MODIFICATION INSTRUCTIONS

KODAK MINILOADER 1M, MODELS STAND-ALONE & PROCESSOR INTERFACE

MODIFICATION No. M03

PURPOSE:

FIGURE 1

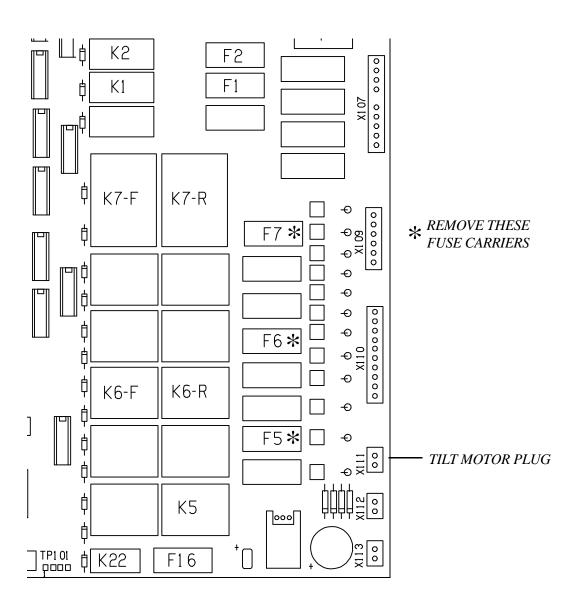
To replace three glass FUSES with auto-resetting devices. This will eliminate service calls that are made purely to replace blown fuses.

- **1.** Turn off the power to the MINILOADER.
- **2.** Remove the TOP COVER and the FRONT PANEL. Make sure you disconnect all CABLES as you remove the FRONT PANEL.
- **3.** Pull the PCB 301 forwards and remove the SCREWS which hold the clear plastic PROTECTION COVER in place. Disconnect the POTENTIOMETER for the TILT MOTOR (PLUG X111) and remove the COVER.
- **4.** Taking ESD precautions, remove the FUSE CARRIERS for FUSES F7, F6, and F5. See FIGURE 1.

5. Using the TABLE below, fit the new MULTIFUSES into the existing FUSEHOLDERS.

FUSE POSITION	PURPOSE	MULTIFUSE	PART NUMBER
F7	CAM MOTOR	R250	30025886
F6	CASSETTE CONVEYOR MOTOR	R250	30025886
F5	TILT MOTOR	R050	30025888
